**Product Change Notification
 2604, 2606, 2616 and 832 Series**

PCN 2019-12-2604-2606-2616-832

Old version	New version
832 Series: 	832 Series:

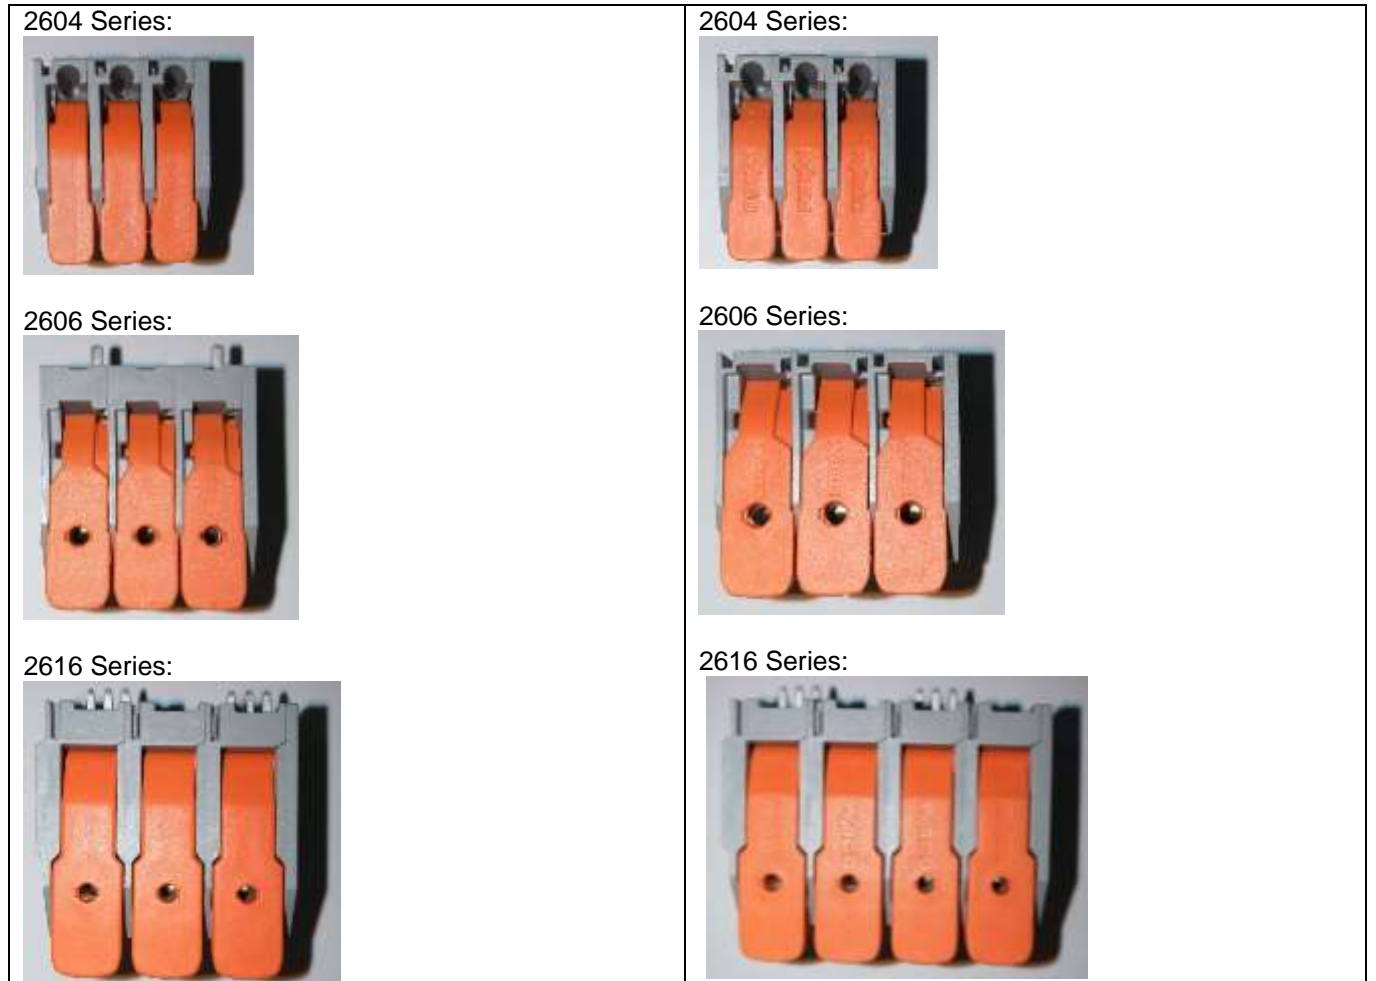
The levers of the above series are affected by a design change and will be delivered in the future with a WAGO logo.
